LOT 11 PARKER POINTE

LOT 11, PARKER POINTE FILING NO. 1
 A PART SECTION 3, TOWNSHIP 7 SOUTH, RANGE 66 WEST OF THE SIXTH PRINCIPAL MERIDIAN
 TOWN OF PARKER, COUNTY OF DOUGLAS, STATE OF COLORADO

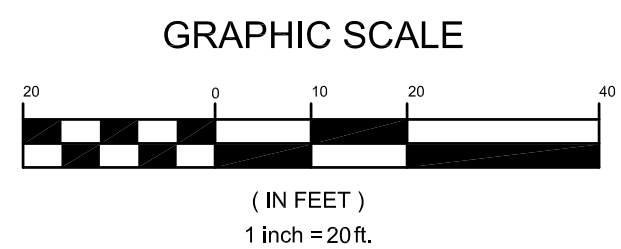
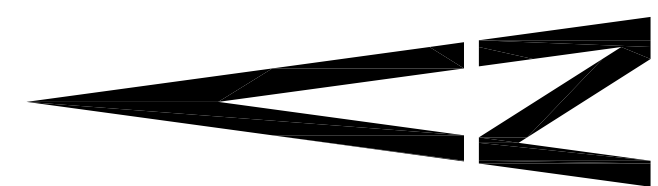
The relocation of HC parking has increased the access issue noted in the initial review comments. A clear walkway of a minimum of 7 feet must be provided. A ramp that leads directly into a patio area that will contain furniture is not accessible.
